Access Compliance Report

Public Rights-of-Way

Intersection ID: 53920	Main Street: STEVIE_OAKS_LN	Cross Street: BRITTONDALE_LN	Location: SE
ADA ID: B914B3EFFF8F	Ramp Type: PerpDiag	Initial Pass/Fail: Fail	Overall Compliance: No
Severity Score: 10			
Codes/Mitigation Info/Possible Solution		Field Measurements/Component Compliance

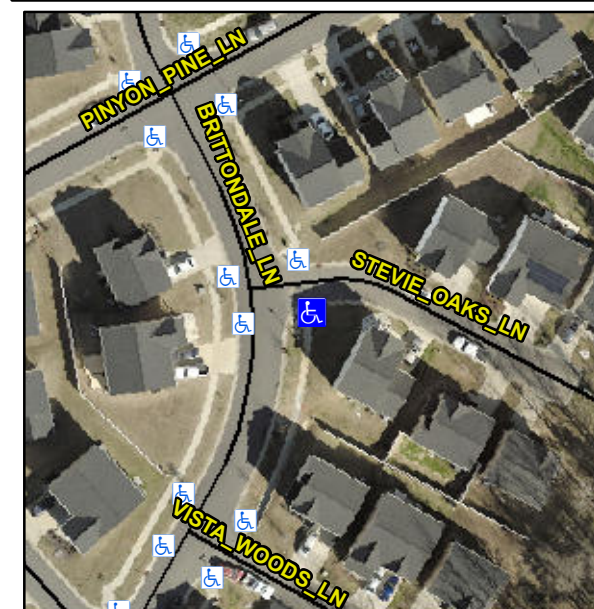
Not Found, R304.5.1, R304.5.3

Compliance	Description	Data	Compliance	Description	Data
N/A	Ramp Length (in)	97.0	Yes	Ramp Slope (%)	7.6
No	Ramp Width (in)	43.0	No	Ramp XSlope (%)	2.4
N/A	Flare Type LT	N/A	N/A	Flare Type RT	N/A
N/A	Flare Slope LT (%)	N/A	N/A	Flare Slope RT (%)	N/A
N/A	Flare Traversable LT?	N/A	N/A	Flare Traversable RT?	N/A
N/A	Landing Length (in)	N/A	N/A	DWS Provided?	N/A
N/A	Landing Width (in)	N/A	N/A	DWS Contrast?	N/A
N/A	Landing Slope (%)	N/A	N/A	DWS Length (in)	N/A
N/A	Landing X Slope (%)	N/A	N/A	DWS Full Width?	N/A
N/A	Landing Curb? (Y/N)	N/A	N/A	DWS Offset (in)	N/A
N/A	Shared Landing?	N/A			
N/A	Gutter Ponding?	N/A	N/A	Gutter Slope (%)	N/A
N/A	Gutter Lip Ht (in)	N/A	N/A	Gutter X Slope (%)	N/A
N/A	Painted X Walk1?	No	N/A	Painted X Walk2?	No
	X Walk 1 Direction	To N		X Walk 2 Direction	To W
N/A	X Walk 1 Width (in)	N/A	N/A	X Walk 2 Width (in)	N/A
	X Walk 1 Slope (%)	6.4		X Walk 2 Slope (%)	3.0
	X Walk 1 X Slope (%)	0.4		X Walk 2 X Slope (%)	4.3

Remove & Replace Curb Ramp With Two New Directional Ramps or Equivalent.
